Change notes since last quote (now at Rev C.)

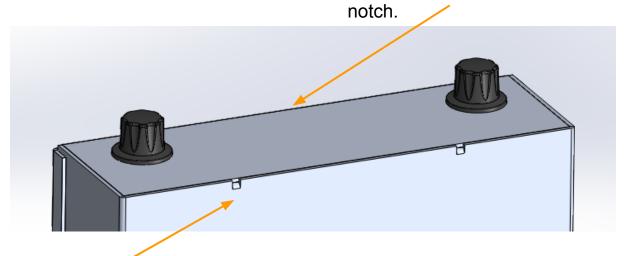
- 1. Material thickness changed from .060" to .050"
- 2. Overall dimensions slightly smaller
- 3. Addition of notches (see below)
- 4. QTY will be 550 pcs, each.
- 5. I am talking to Roy about finish. We'll run two different colors, ANSI 61 Gray with black screenprint, and FED STD 34094 Green, with white screenprint. Final batch sizes TBD.
- 6. Artwork for screenprints is attached

can this edge be overbent slightly to improve fit? the face will then squeeze the

notch is intended to support case wall.

can the notch be formed on the turret punch?
